RPRC DETERMINATION LETTER

Project Description: New two story modular home, (5) bedrooms, (6) bathrooms, (3) car garage, and pool

34 CREEMER RD

Zoning District: R-2A Tax ID: 108.04-2-14 Application No.: 2023-0515

4 RIGHT ELEVATION
1/4" = 1'-0"

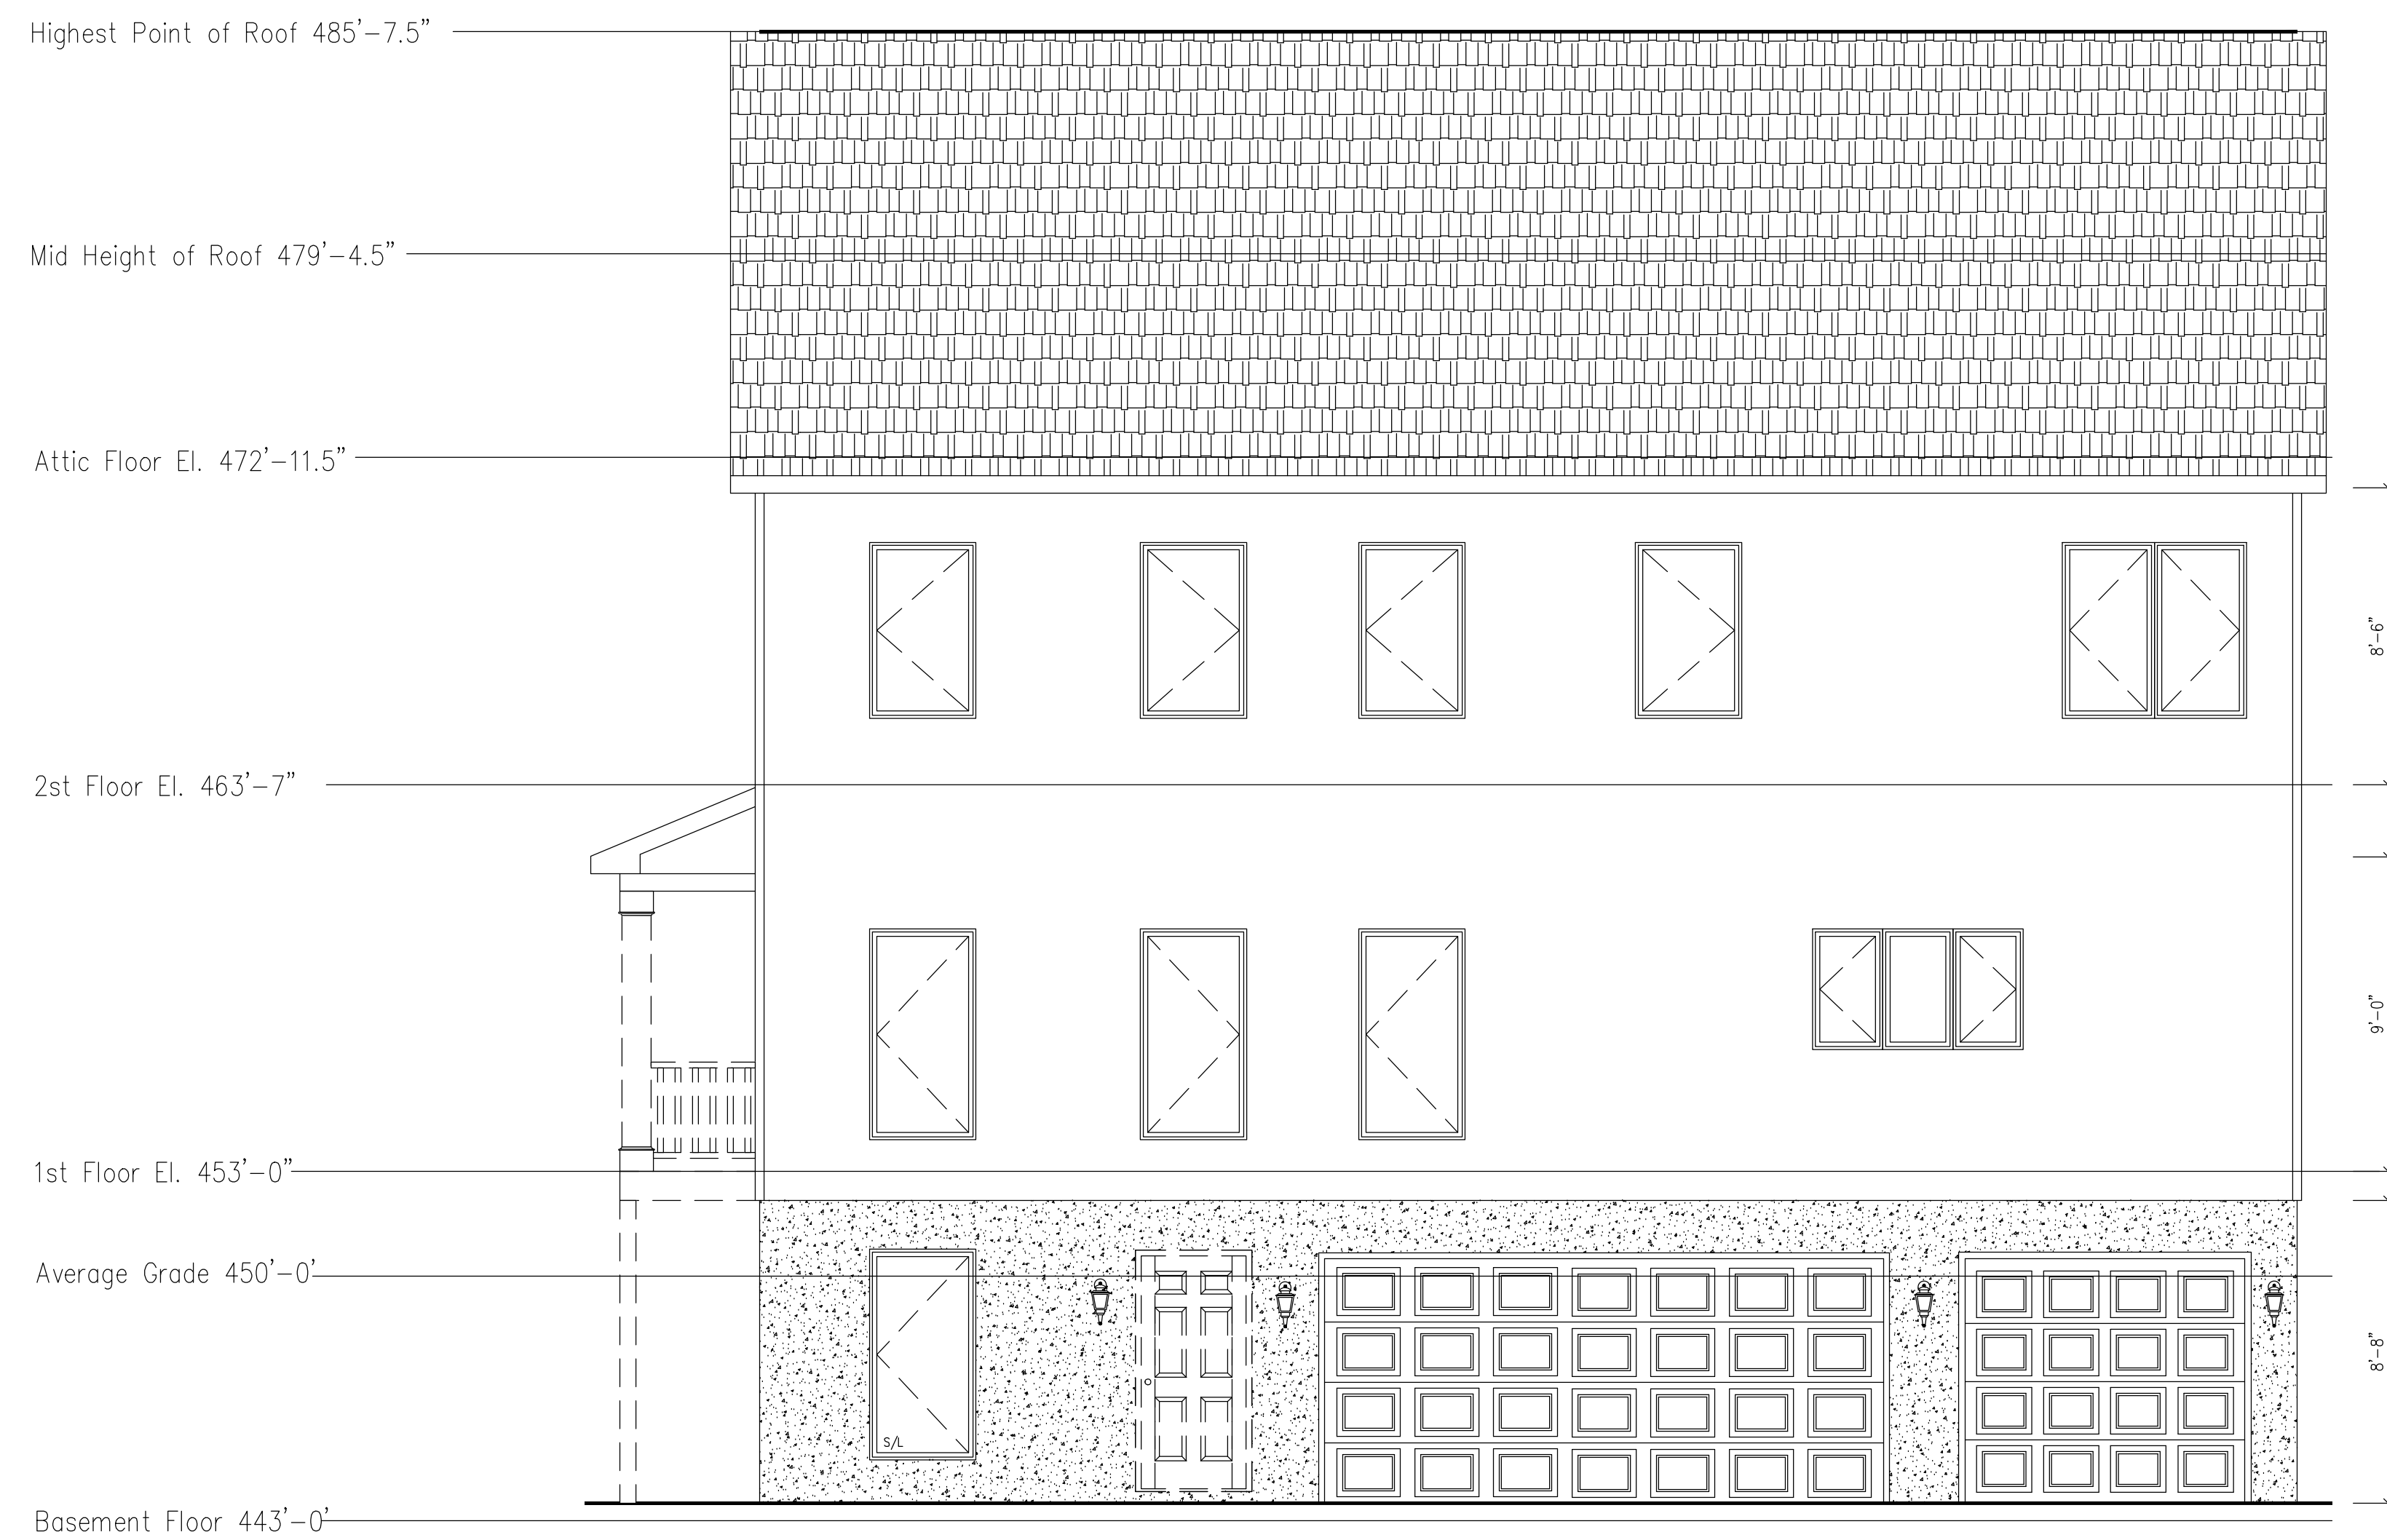
- In addition, the Applicant didn't provide an updated mitigation plan for review. Some of the submitted elevations are not two dimensional. The submitted elevations should be in two dimensions with an elevation submitted for each side. The Applicant can submit proposed renderings for additional information.

- The elevations should be revised to depict Building Height (average grade to roof midpoint - max 30 feet) and Max. Ext. Wall Height (lowest grade to roof midpoint - max 38 feet).

SITE DATA	
OWNER/APPLICANT: 34 CREMER LLC	
SITE ADDRESS: 34 CREMER ROAD, ARMONK, NY 10504	
TAX MAP #: 105.04-2-14	
LOT AREA: 2.1465 ACRES	
ZONING: R-2A	
REVISED: JULY 20, 2023	
SITE PLAN MAY 22, 2023	
PROJECT: 34 CREMER ROAD TOWN OF NORTH CASTLE, WESTCHESTER COUNTY, NEW YORK

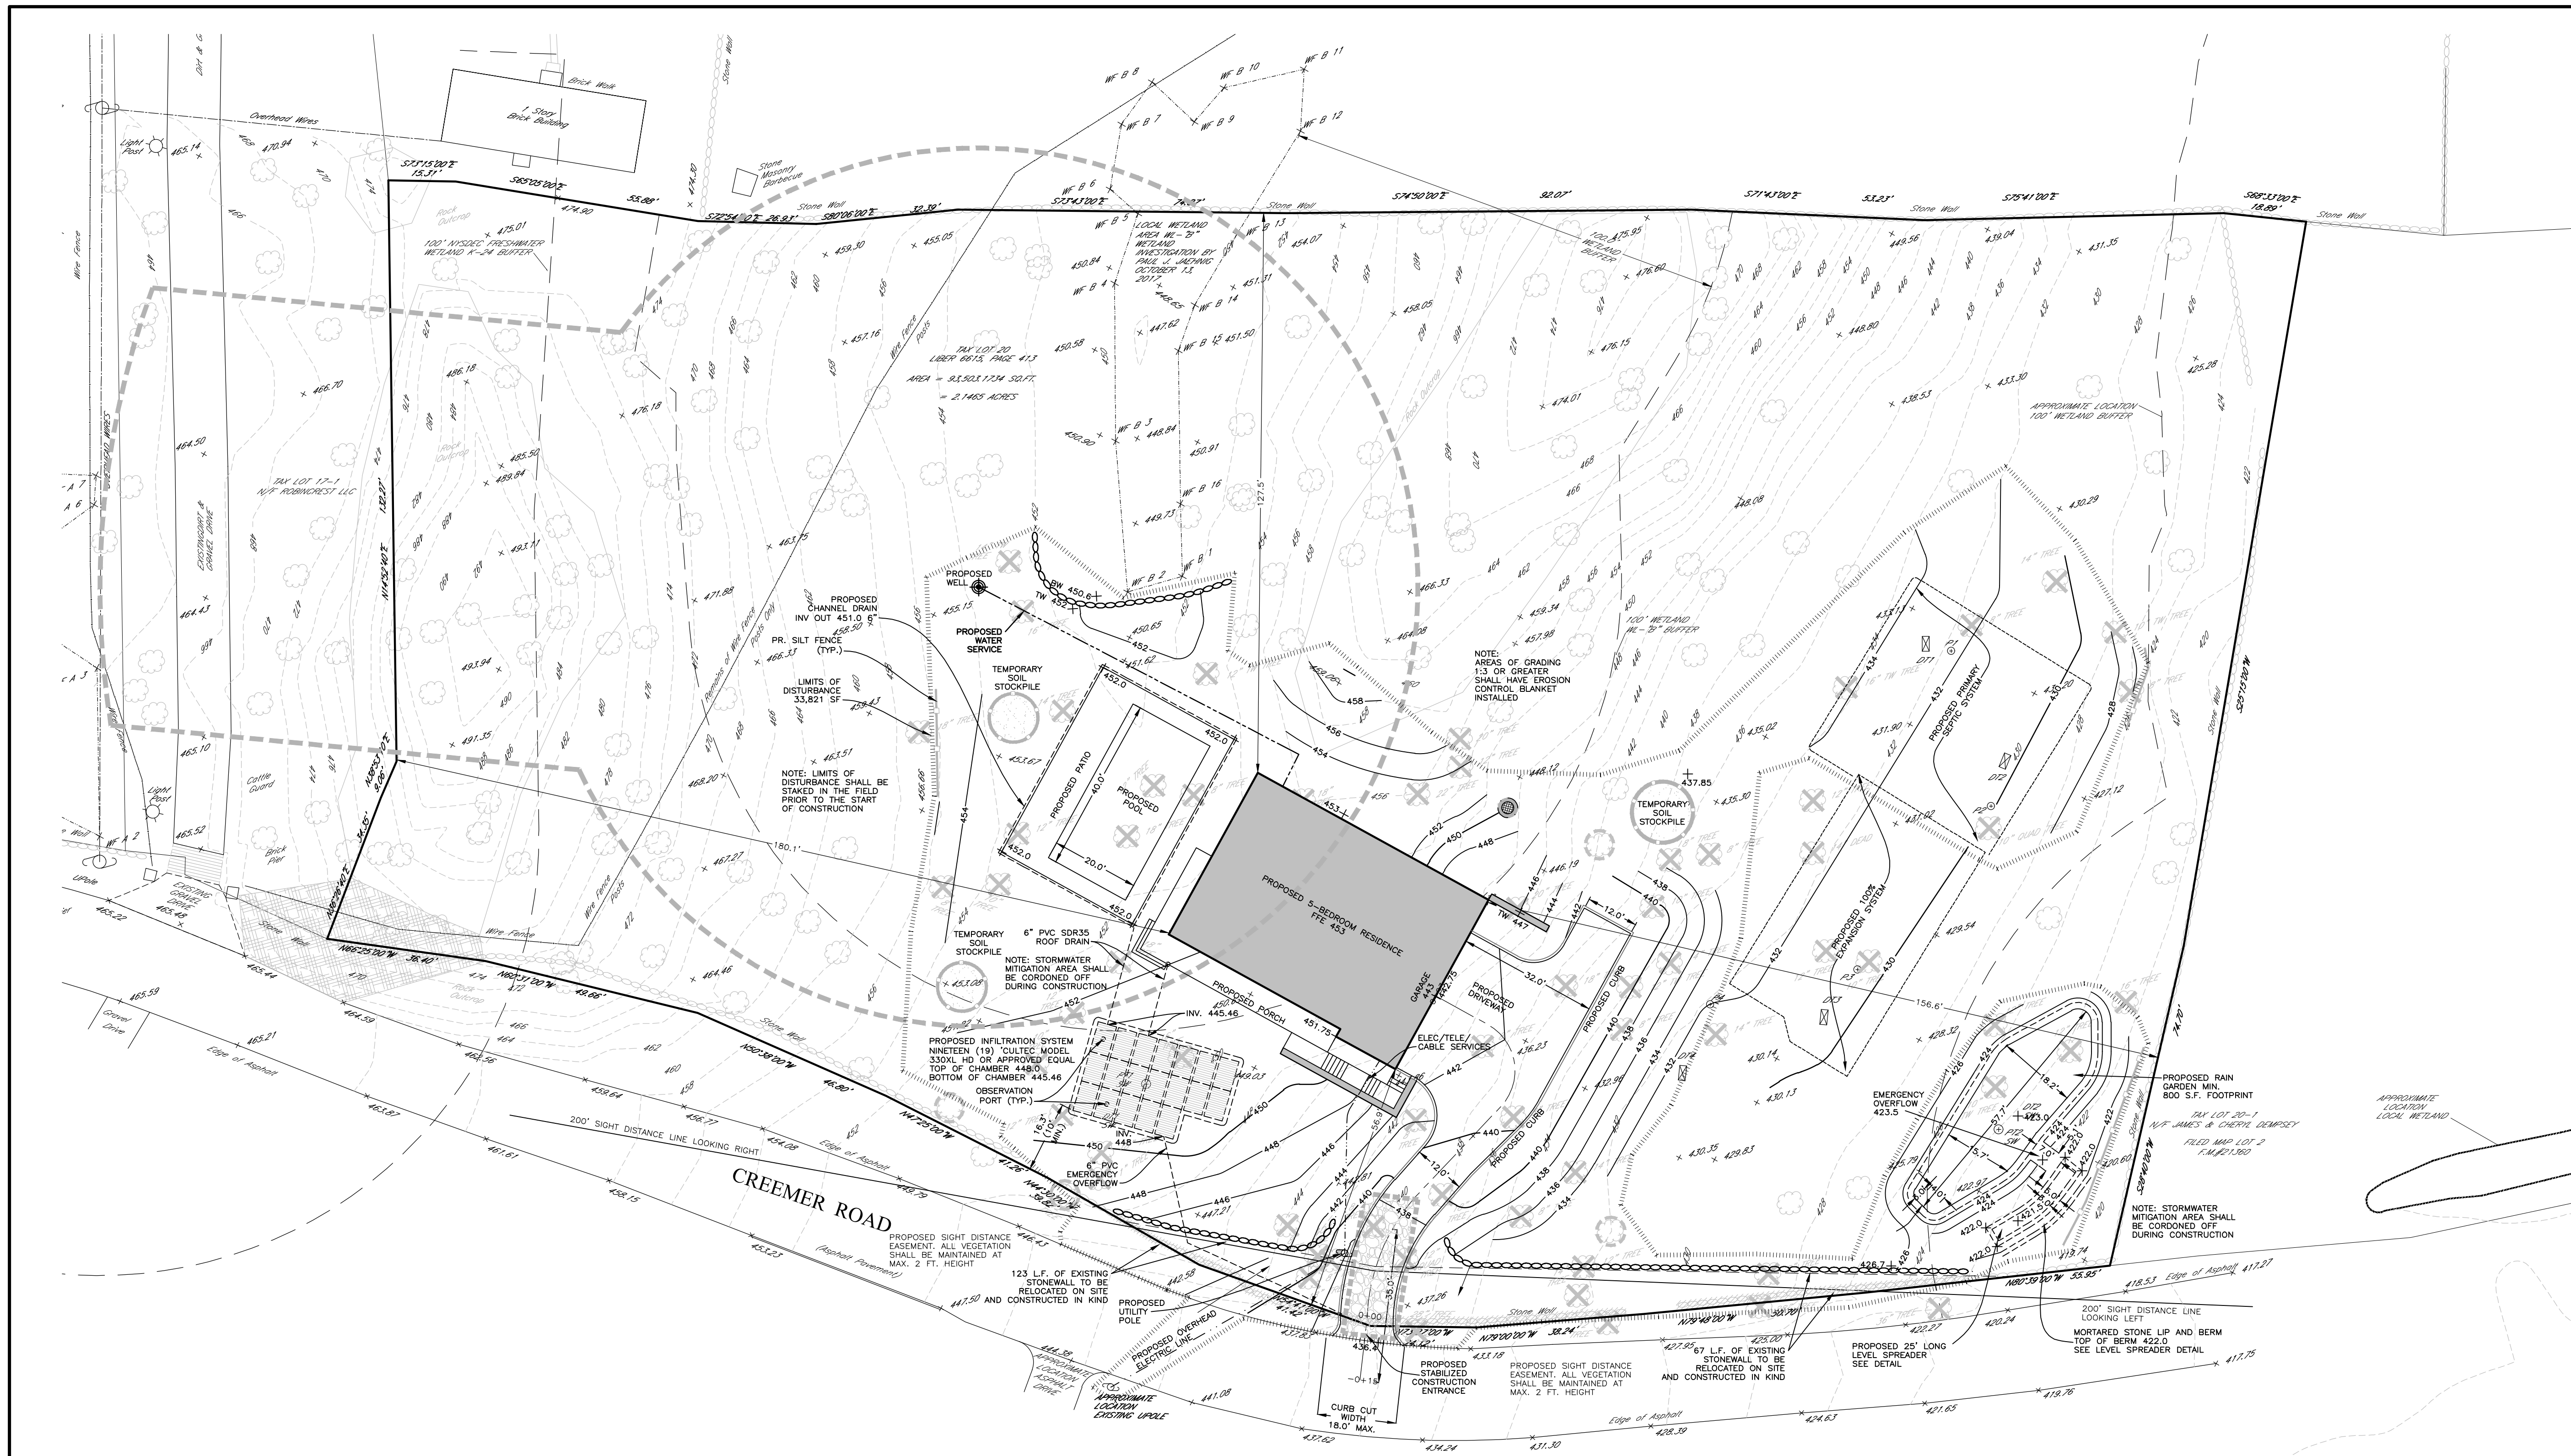
- The major amendment to the plan is the construction of a proposed new inground pool located entirely in a Town-regulated wetland buffer. Typically, recreational amenities located entirely in an undisturbed wetland buffer are highly scrutinized.

- The applicant should submit a landscape and mitigation plan for review. The mitigation plan shall demonstrate that the mitigation plan is at least twice the size of the proposed wetland and buffer disturbance.

The applicant has not provided the new disturbance limits or area of new impervious surfaces in comparison to the previously approved project. However, since the stormwater mitigation system has increased in size, I would assume the impervious coverage also increased. The applicant will need to update the wetland buffer disturbances, update the required mitigation, mitigation bonding requirements and update Stormwater Pollution Prevention Plan to address changes of the project.

Pool foot print replaces original larger house & driveway foot print

The net required mitigation has been slightly reduced as a result of the new design.

Please, see attached site plan with updated mitigation.

Please, see attached updated site plan and landscape plan

Please, see attached updated site plan and landscape plan
